Access Compliance Report

Public Rights-of-Way

Intersection ID: 54219	Main Street: SANDY_ROCK_PL	Cross Street: NORTH_REA_PARK_LN	Location: SE
ADA ID: DE47C938A762	Ramp Type: BlendTrans1	Initial Pass/Fail: Pass	Overall Compliance: No
Severity Score: 0			
Codes/Mitigation Info/Possible Solution		Field Measurements/Component Compliance

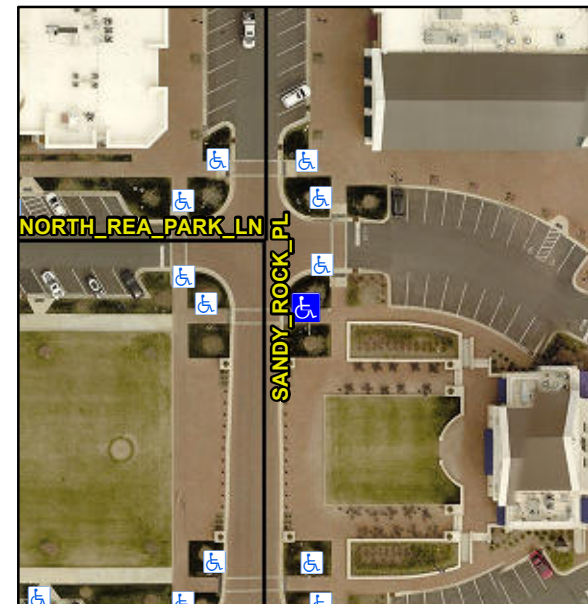
Remove & Replace Curb Ramp With Two New Directional Ramps or Equivalent.

Not Found, R304.2.2-Perp, R304.3.2-Para
